#### Thursday, March 24, 2022

# **Certificates of Appropriateness**

### Case 22-004: Rockefeller Park (Concept Plan 1/13/22) Jesse Owens Olympic Oak Plaza Martin Luther King, Jr. Drive Landscaping and Site Improvements Ward 7: Howse Project Representatives: Elise Yablonsky, University Circle, Inc.; Jayme Schwartzberg, DERU Landscape Architecture; Angelica Pozo, Artist

# **Case 22-023:** Ohio City Historic District (Concept Plan 2/10/22) **Wells Residence 4612 Clinton Avenue**

#### Waverly & Oak Phase 2 5416 Detroit Avenue

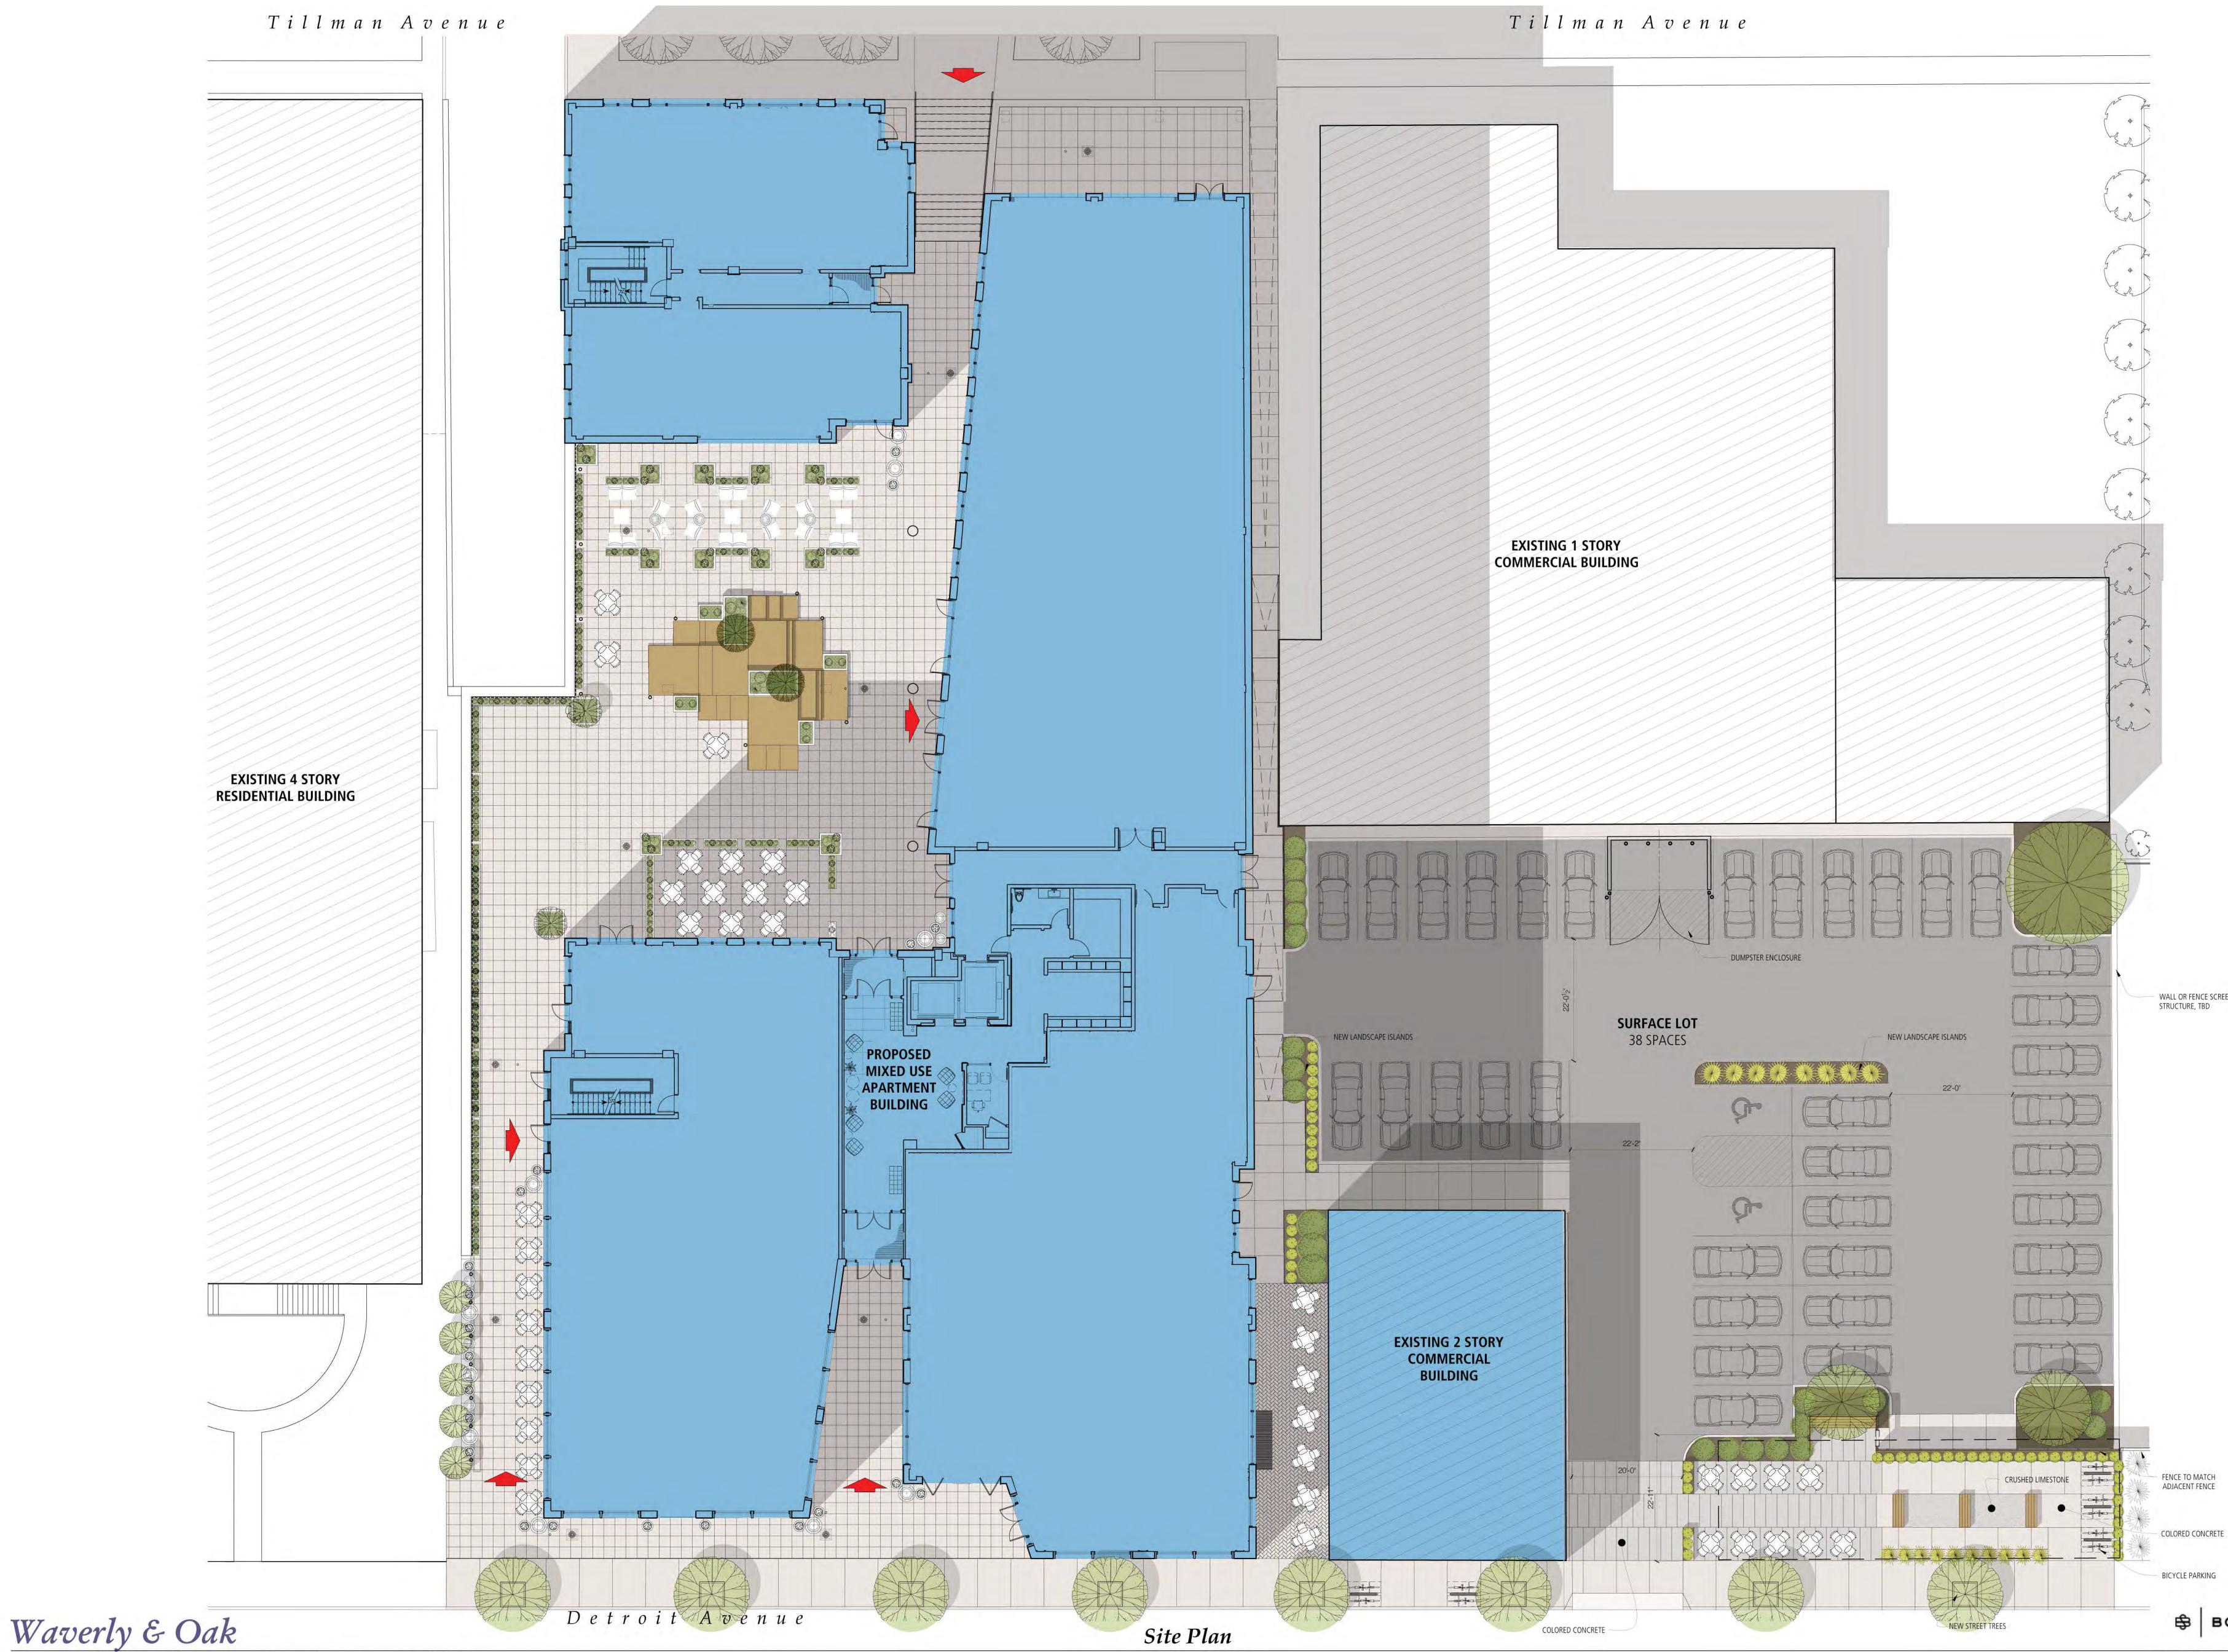
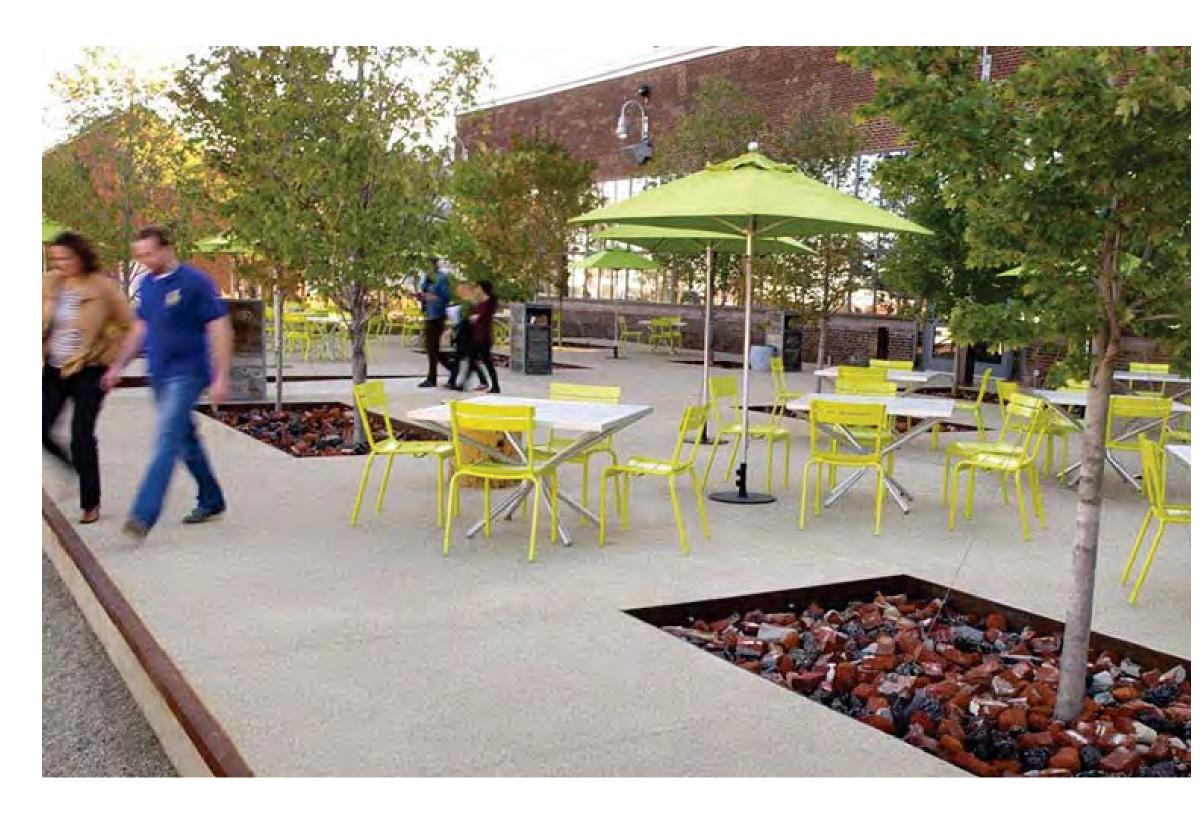
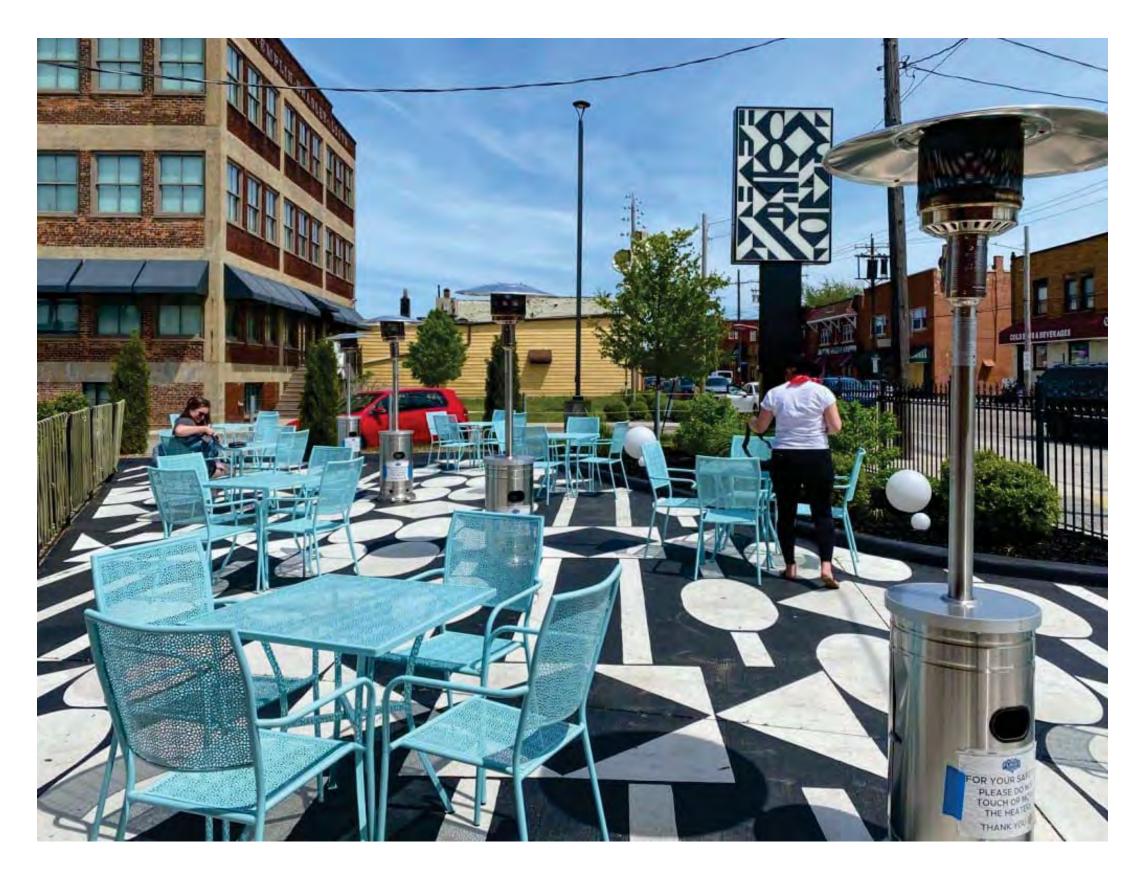
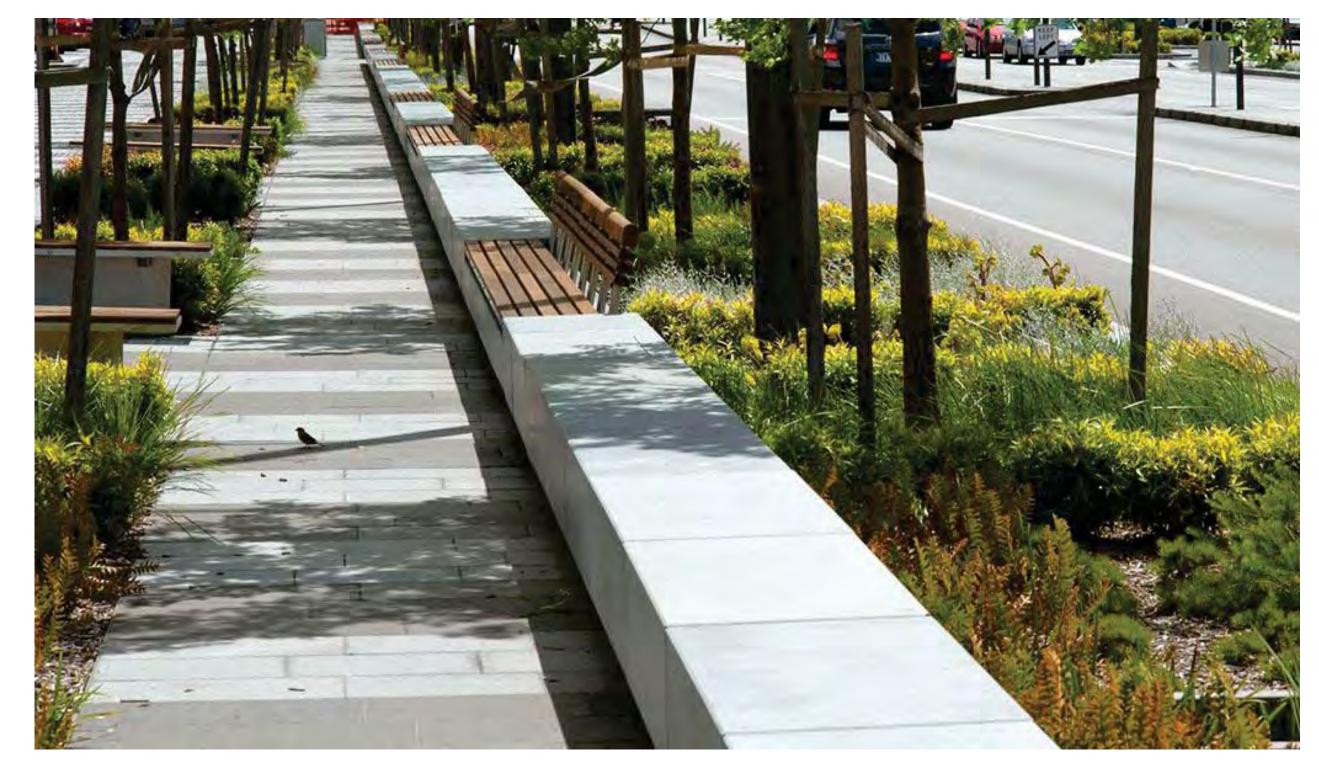
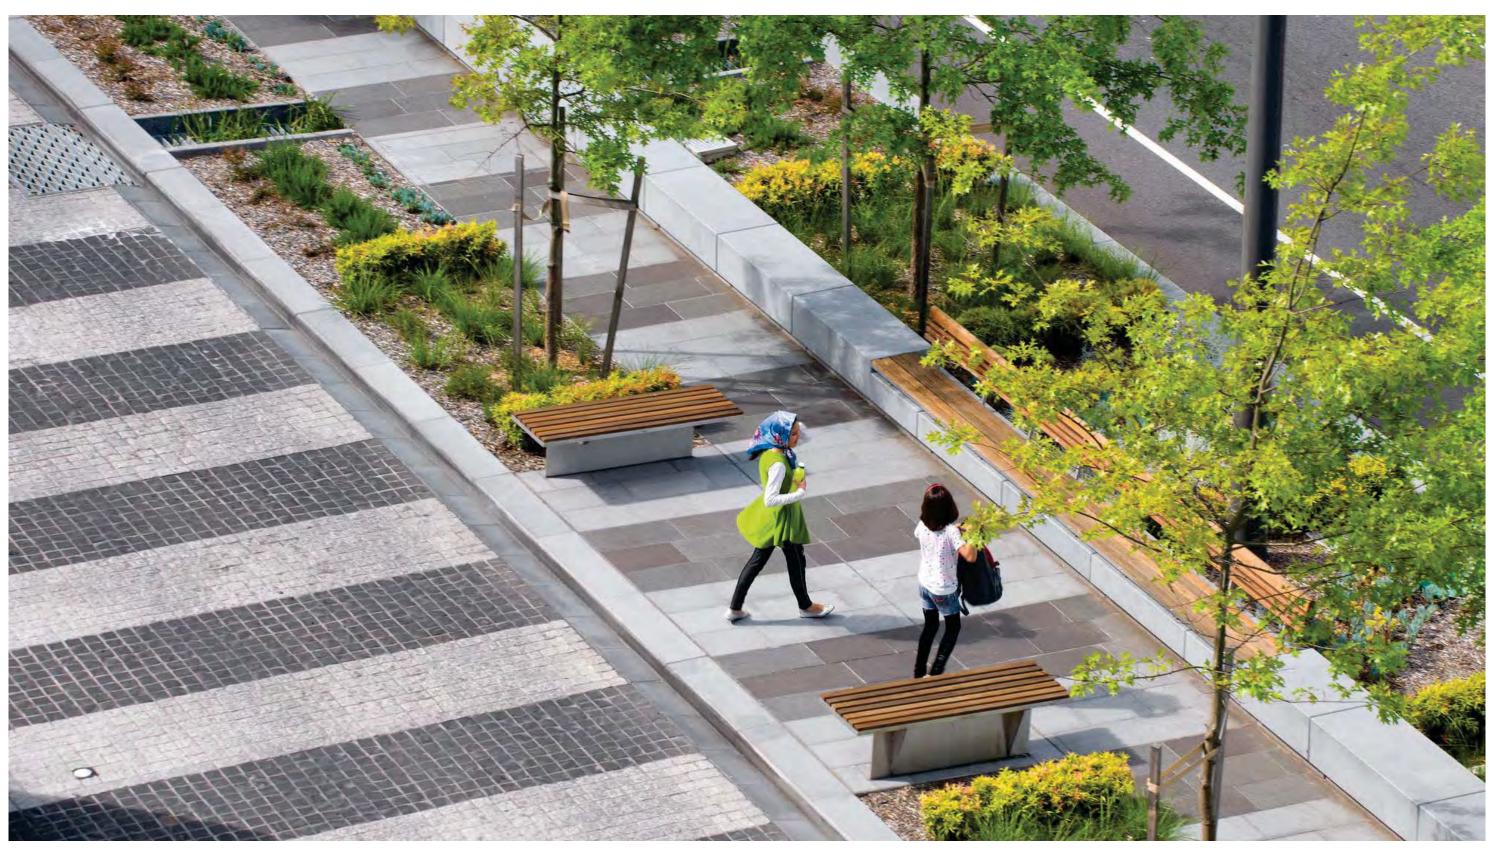
**Specifications of work proposed:** Proposal to demolish existing non-contributing structure, add temporary park, discuss potential options for future development on site. Setback increased to about 37' to meet PRO requirements (still needs conditional use)

- 1) Recommend approval of the demolition of 5416 Detroit Avenue
- 2) Recommend approval of the site plan hardscape with the pocket park hardscape to be studied for more overall greenspace, more elements for site and seating with final landscape selections to return to the committee
